**Project: IEEE P802.15 Working Group for Wireless Personal Area Networks (WPANs)**

**Submission Title:** [Consideration of MR-FSK Channelization and Clock Frequency Tolerance Using Filtered FSK]

**Abstract:** [Evaluation of the MR-FSK channelization scheme and the effect of clock frequency tolerance with filtered FSK as modulation format.]

# Adjacent Channel Rejection Test

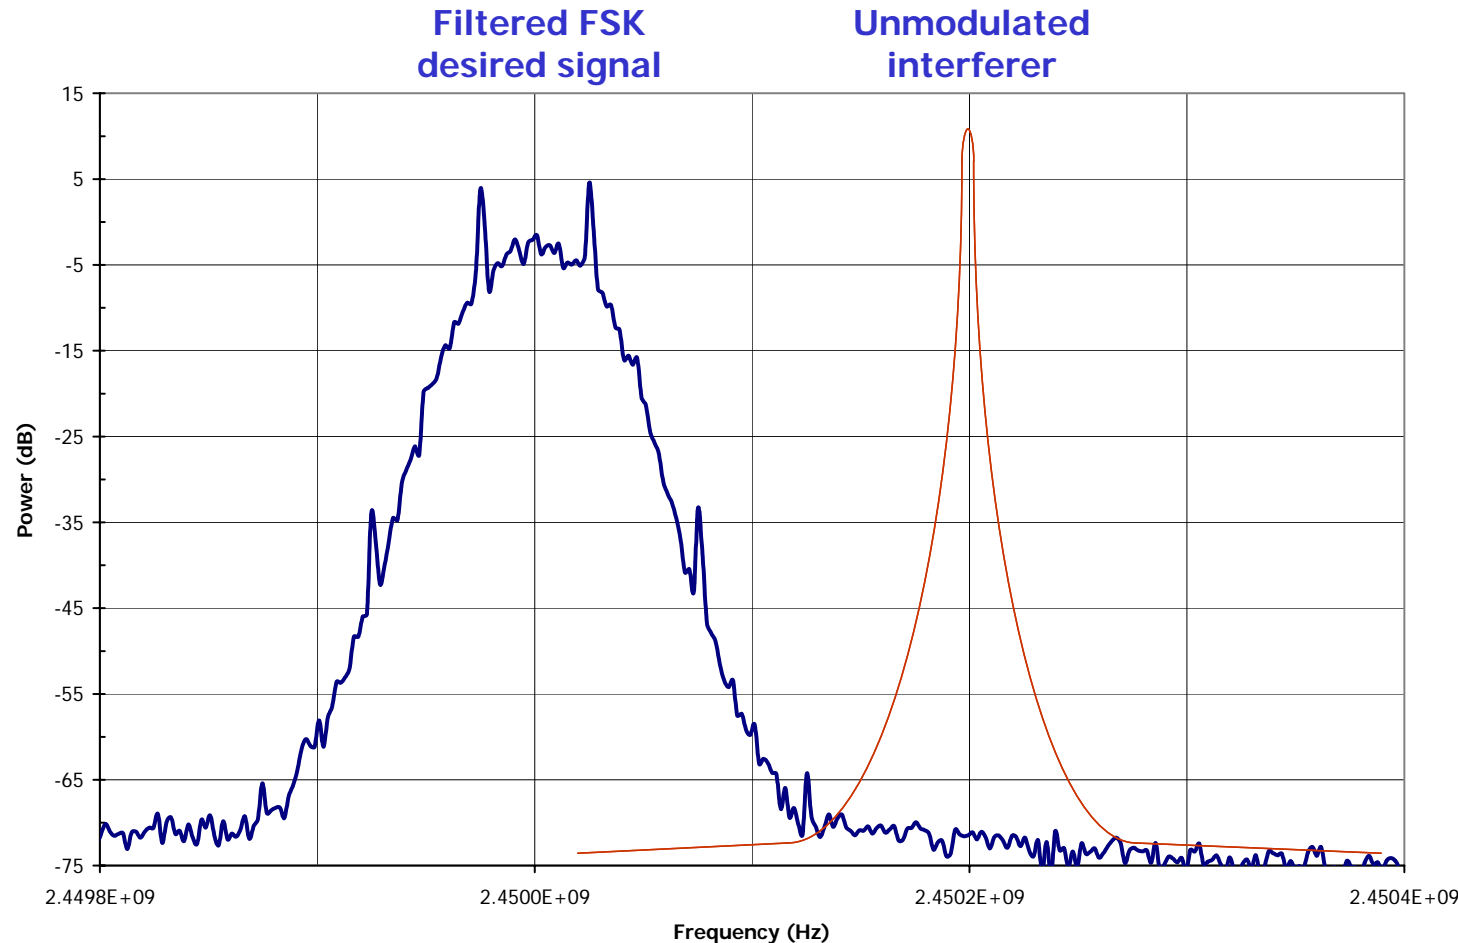
- The adjacent and alternate channel test using ‘an unmodulated carrier in the center of that channel’ is most likely too optimistic.  
The recommendation is to change the interfering signal in the adjacent channel to a modulated signal in order to achieve more realistic evaluation of the receiver performance.  
The MR-O-QPSK and MR-OFDM PHY options use modulated interferer.
- The existing channel scheme and clock frequency tolerance work well at the 2400-2483.5 MHz band.  
A clock tolerance of  $\pm 20$  ppm seems feasible at the 2.4 GHz band without further changes.
- The adjacent channel and alternate channel rejection requirements of respectively +10 dB and +30 dB (relatively simple to implement on low cost low power radios) are at a reasonable level for the 15.4g MR-FSK channelization scheme.

**AP:** In 6.12a.4.3 change the interfering signal in the adjacent and alternate channel to a modulated signal with the same characteristics as the wanted signal.

# Filtered FSK Signals at 2450 MHz, $\pm 15$ ppm (2)

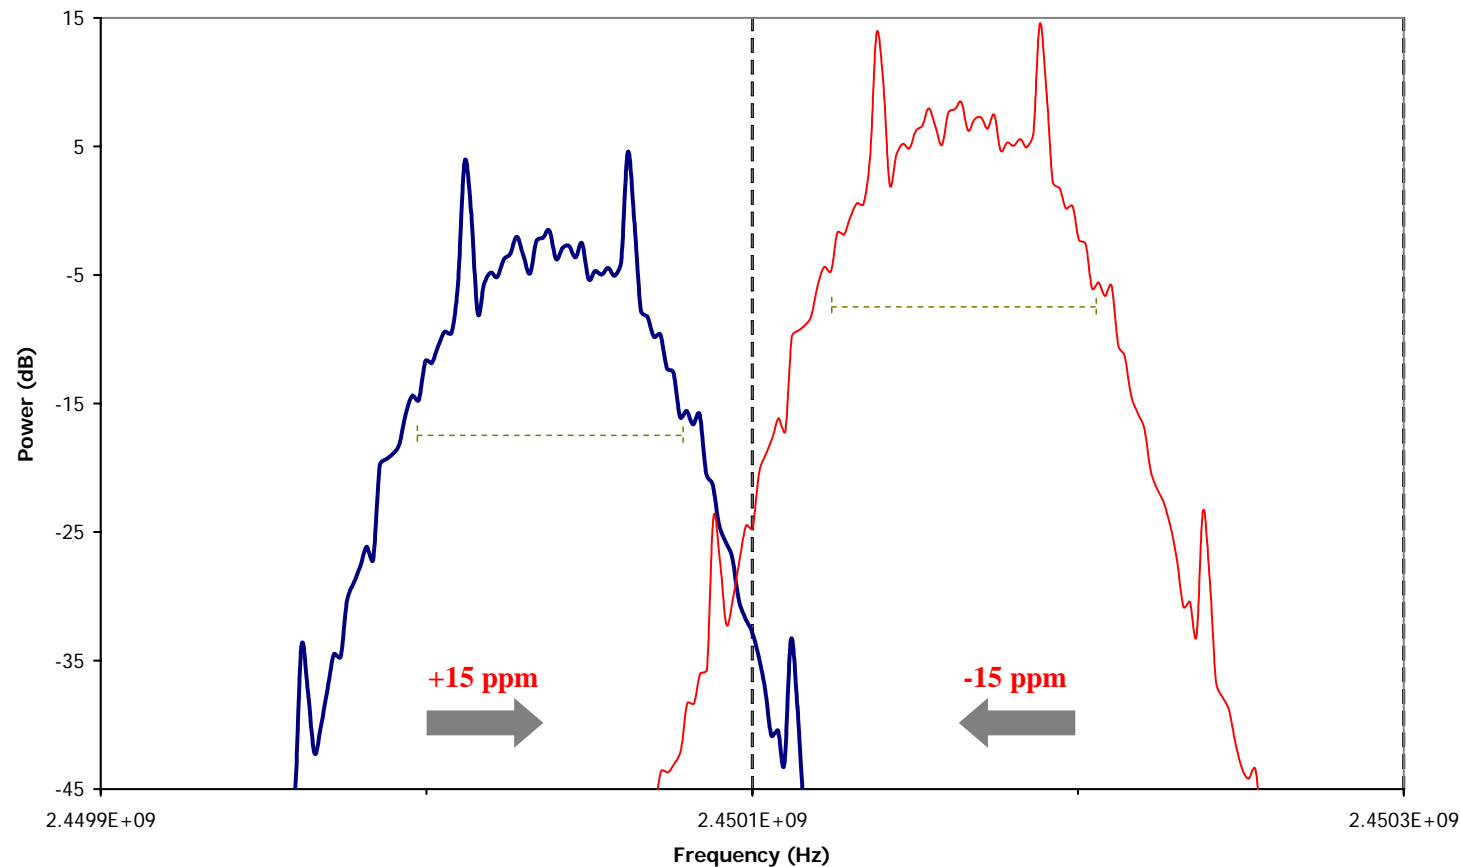
- $\pm 15$  ppm (max frequency tolerance)
- Worst case frequency offset
- All signal power contained within the channel
- Good conditions for signal demodulation

Comment: “For the 2400-2483.5 MHz band, a channel spacing of 200 kHz imposes unnecessary tight bounds on the maximum transmit center frequency tolerance (+- 15 ppm for the mandatory mode as shown in 6.12a.4). This specification does not harmonize with the MR-OFDM and MR-O-QPSK PHY operating in the same frequency band with up to +/-20 ppm. See document 15-10-0834 for further details.”

**AP:** Same resolution as CID 186.

# Filtered FSK Signals at 2450 MHz, $\pm 20$ ppm

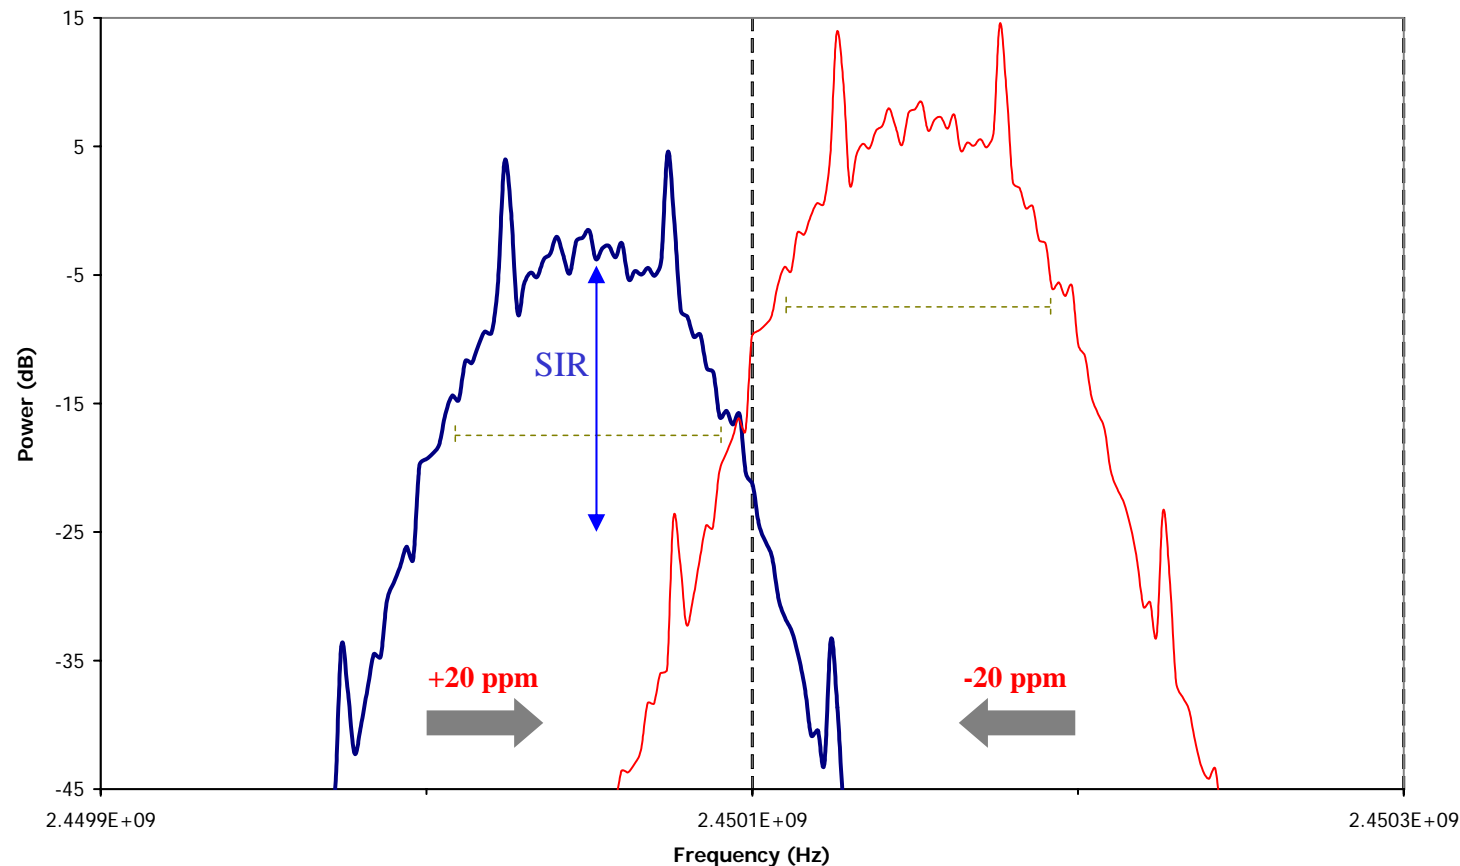
- $\pm 20$  ppm (33% higher than currently specified)
- Worst case frequency offset
- Most of signal power (>99%) still contained within the channel
- Adequate conditions for signal demodulation
